**RE: Geotechnical Review Memo, Native/Pierre Mine, Permit No. M-1977-321,
Conversion Application (CN-01)**

Re: **Native/Pierre Mine; M-1977-321; Kidd Engineering Report for 1224 Ruppel Street;
Geotechnical Review Memo**

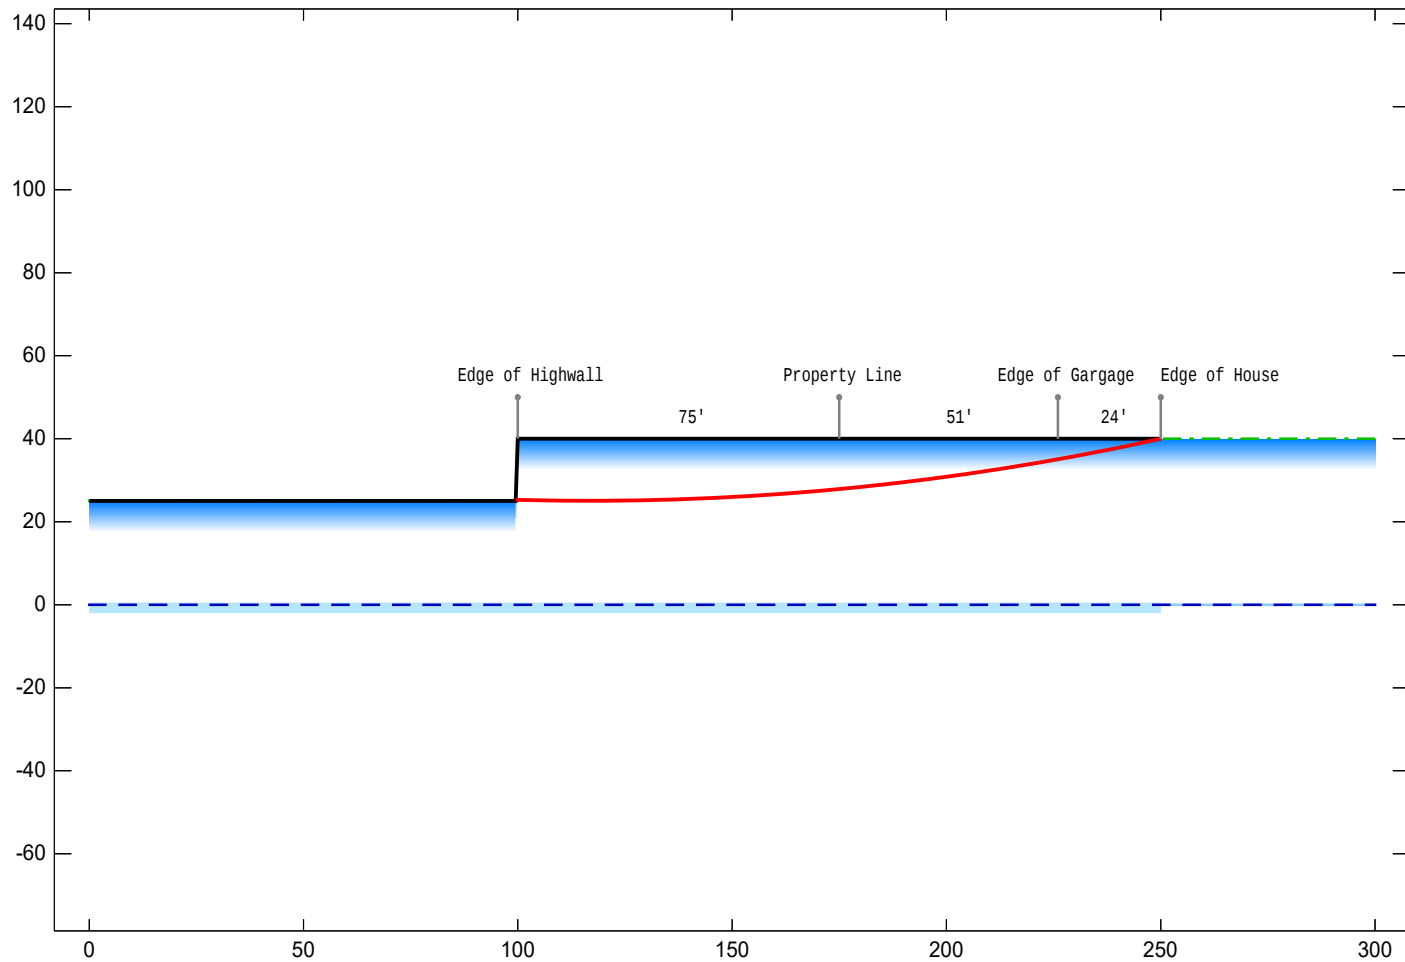
The Division modeled a slope stability analysis using Clover Technologies Galena Slope Stability Analysis System, Version 7.2, based on the information presented in the Kidd report with generic clay soil properties. The analysis resulted in a Factor of Safety (FOS) of 6.05 from the south edge of the house to the existing mining highwall. A copy of the results from the analysis are attached.

In accordance with Table 1 - Recommended Factors of Safety for Slope Stability Analysis for Operations and Reclamation within Section 30.4 of the Policies of the Mined Land Reclamation Board (MLRB) effective May 16, 2018, the Division would require a factor of safety (FOS) of 1.5 for critical structures in static conditions utilizing generalized strength measurements in the analysis.

Based on the information presented in the report and the results of the Division's slope stability analysis, the Division agrees with the conclusions of the Kidd report that the house damages appear to be caused by differential settlement and are not due to the mining operation.
